**RE: Expedited Settlement Agreement, Number ES-150421  
CDPS Permit No: COR-03I226 & COR-03M867**

**Re: Facility Inspection / Compliance Advisory**  
American West Construction LLC  
CDPS Permit No. COR03M867 - DIA Drainage Way Improvements  
CDPS Permit No. COR03I226 - Terminal Water Quality Pond

## Stormwater Inspection Report

**Permittee:** American West Construction LLC      **Cert#** COR03M867      **Report Date:** December 2, 2014

**Photograph 60:** Straw wattle not installed or maintained per specification in SWMP

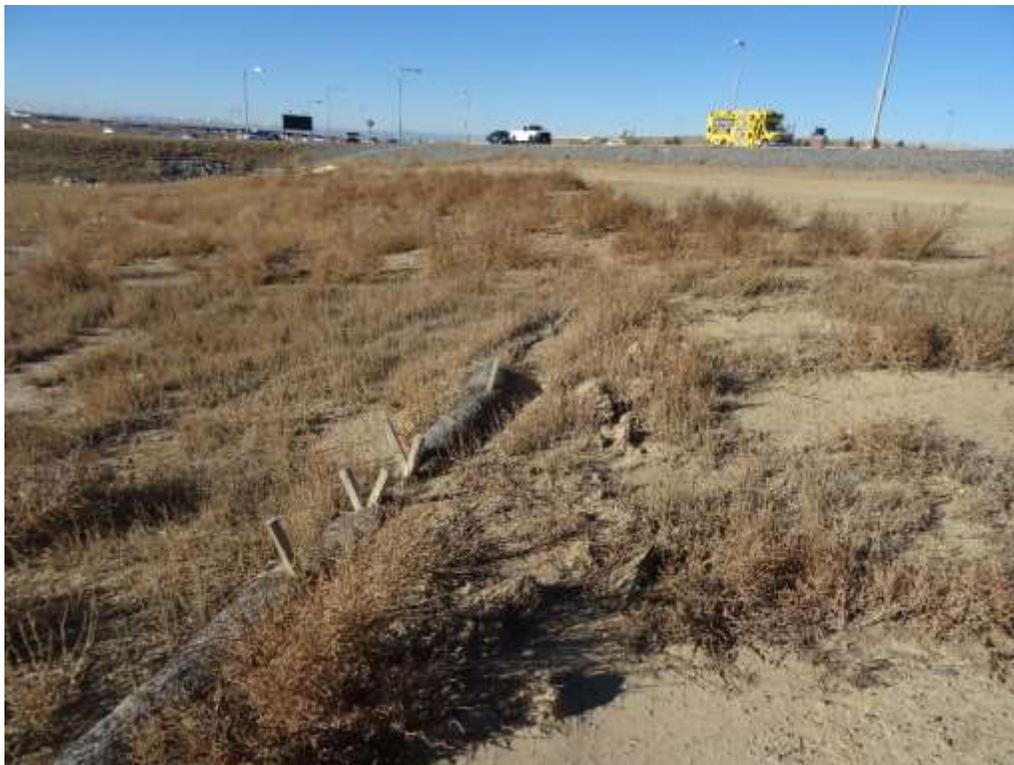
1. It was noted during the inspection that inadequate control measures were implemented to manage pollutant contributions to stormwater runoff from sediment from disturbed areas located along the boundaries of the project site and sporadically through the site (refer to photograph(s) 01 - 68).

- Control Measure Observation: A straw wattle control measure was implemented to manage stormwater runoff from the location and pollutant source noted above; however the control measure was inadequate.

- The straw wattle observed during the inspection was not installed consistently per common industry standards and specifications.
    - Several sections of wattle were significantly damaged with major holes and tears.

- Wattles were in need of maintenance to remove sediment accumulations and to repair areas that were being bypassed or undercut by runoff and up-gradient erosion and riling.

- Result: There was a potential discharge of pollutants to the following state water(s): Third Creek
  - Expectations: The division expects the permittee to design and implement control measures as required by the permit and make the following corrections:

- Maintain all erosion and sediment control practices and other protective practices in good and effective operating condition.
    - Design and implement control measures following good engineering, hydrologic and pollution control practices to prevent pollution or degradation of state waters and document in the SWMP.

**Photograph 28:** Rock sock overtopped by sediment, maintenance needed

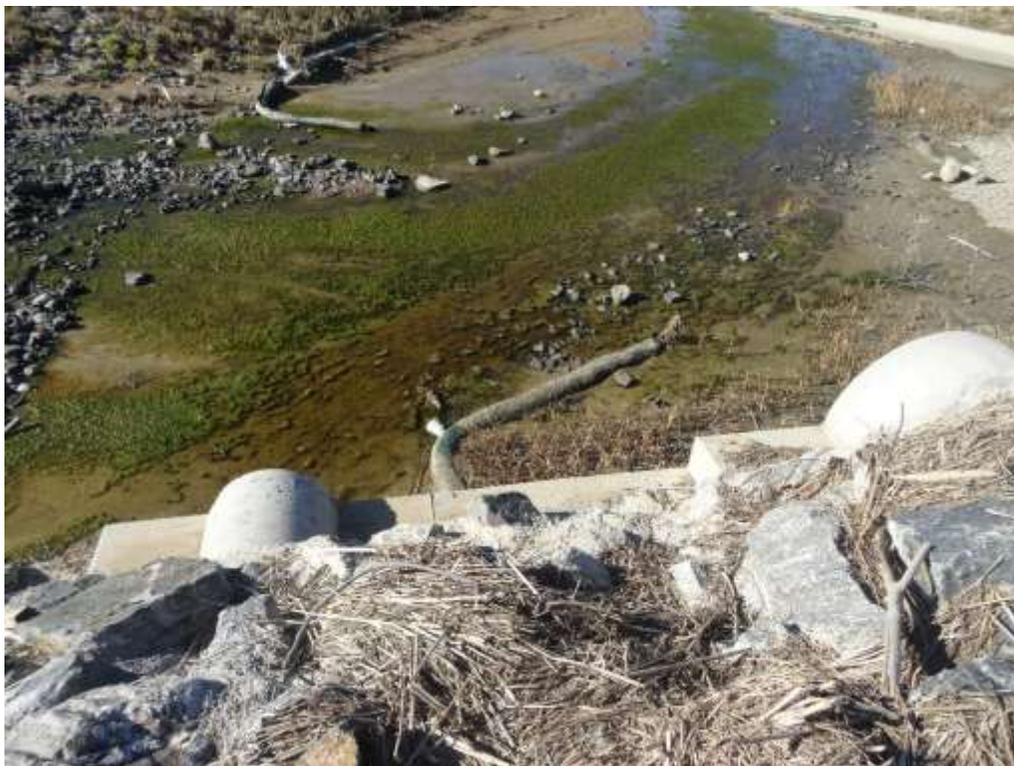
- Control Measure Observation: A rock sock/dandy product control measure was implemented to manage stormwater runoff from the location noted above; however the control measure was inadequate.
  - The rock socks/dandy products observed were not installed in accordance with common industry standards.
  - The rock socks/dandy products observed were in need of maintenance to remove accumulated sediment around the control measures.
  - AWC submitted an inactivation notice to the division on 06/13/13 that certified that all ground surface disturbing activities at the site had been completed and temporary control measures removed.
